Submittal No.: 03a: Containment Drawings & Calculations

Description: Proposal/Contract Number: Bradford-Newbury IM BPNT (14)
Letting Date: 10/10/14; Award Date: 11/03/14
Project Description: Bridge Painting of Five Bridges
In the Towns of Bradford & Newbury, VT
Contract Amount: \$4,327,785.00; Completion Date: 08/26/16

Revision:

ABRASIVE BLASTING
 CONTAINMENT PLANS

MID BAY CABLE ATTACHMENTS

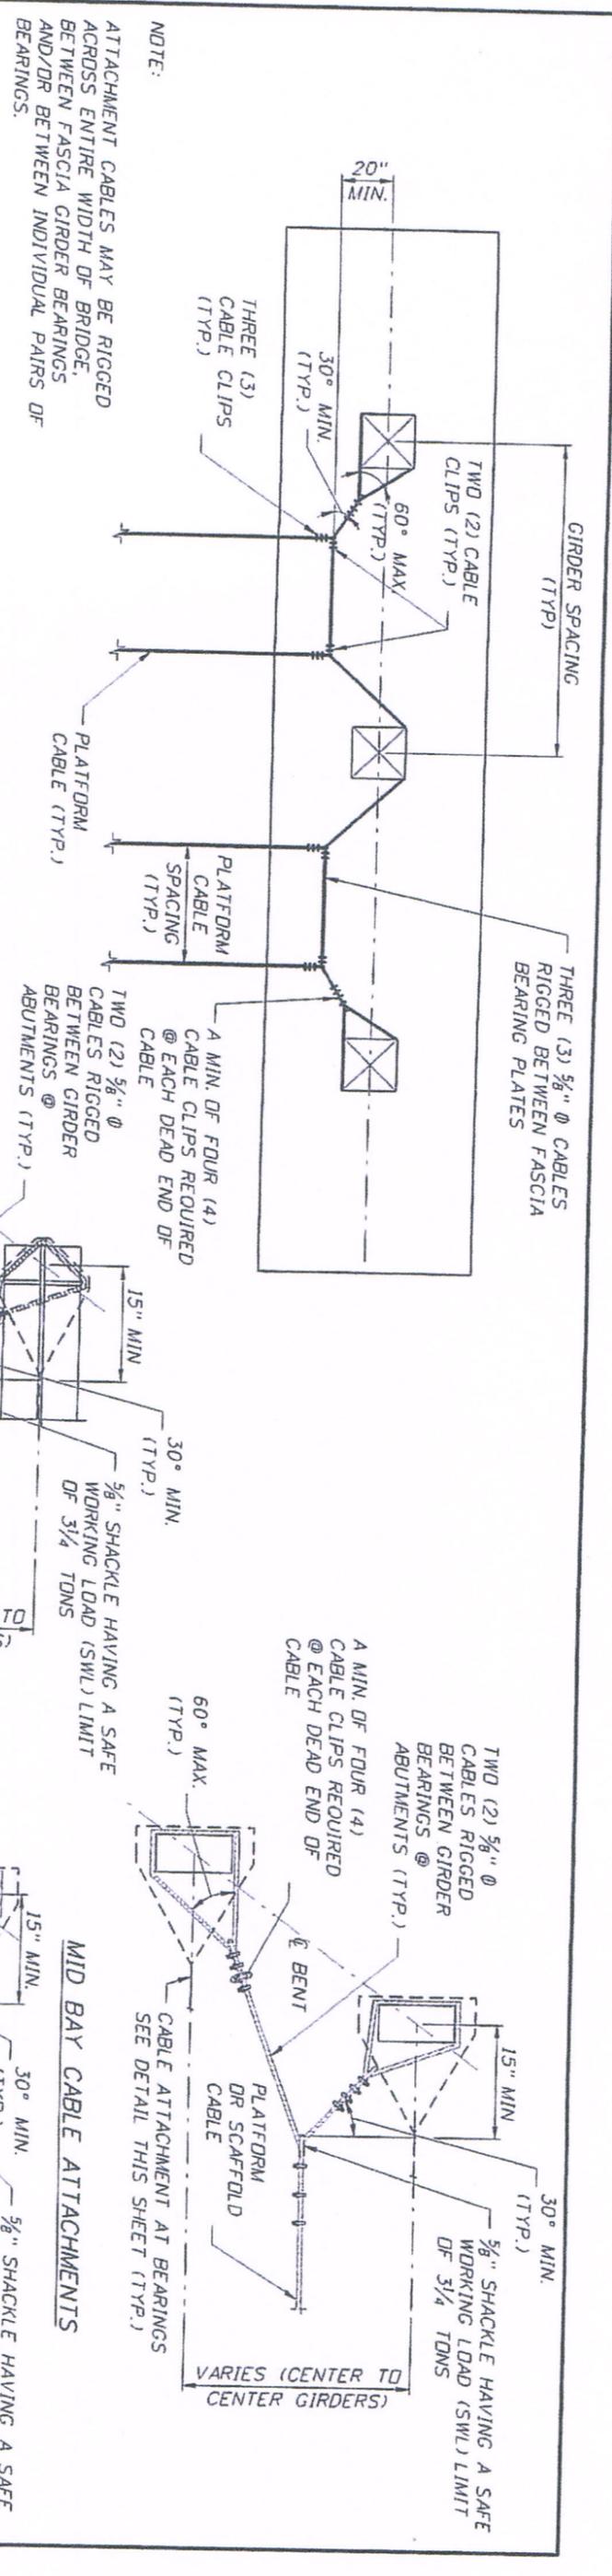
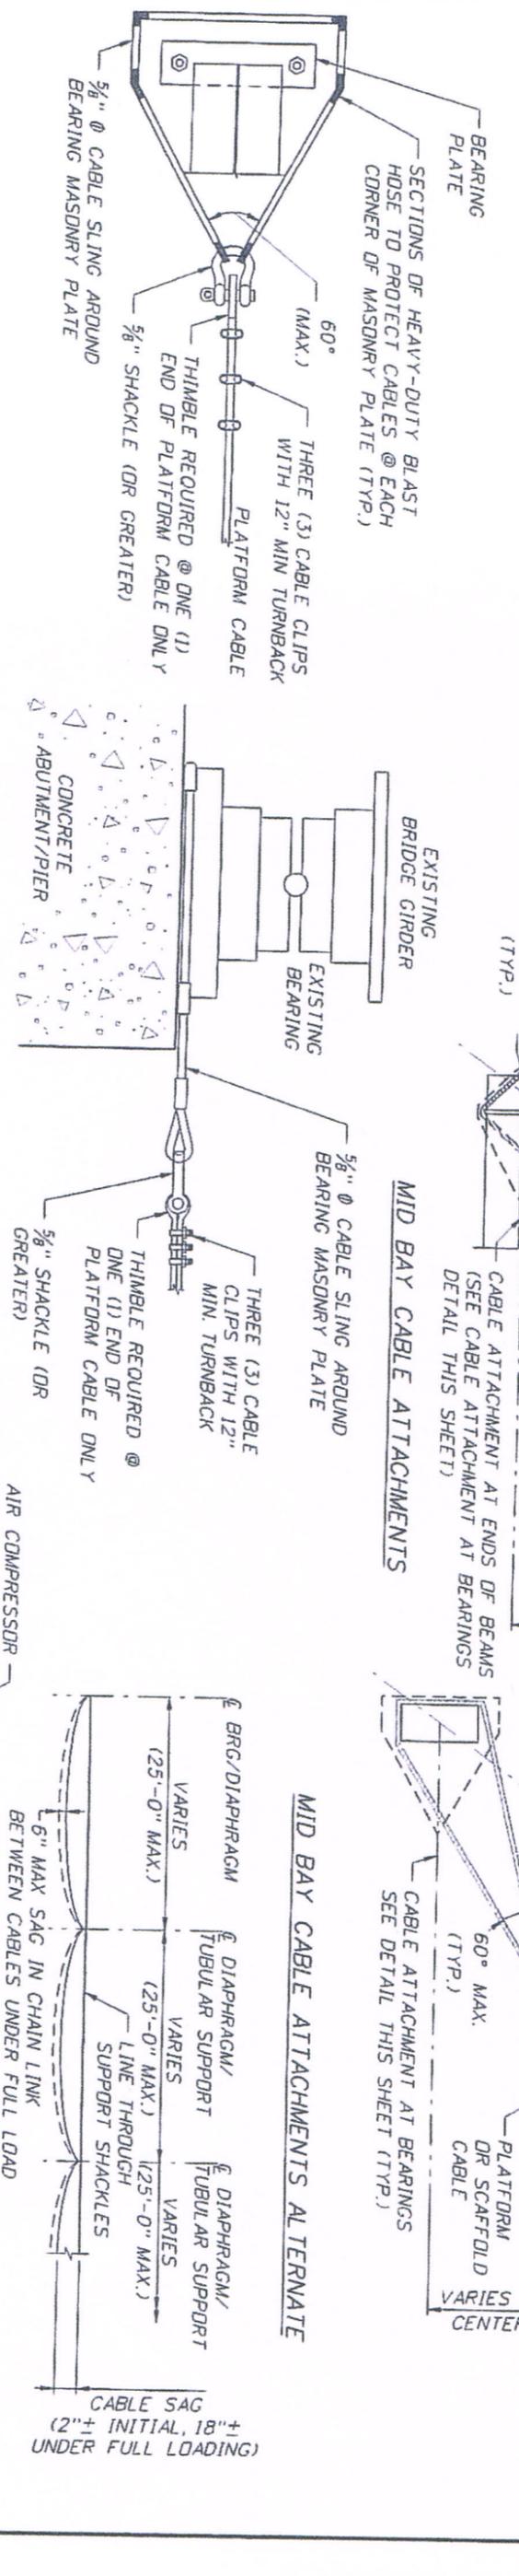
See page C-17 revision to "[Mid Bay Cable Attachments](#)".
Calculations submitted have not changed.
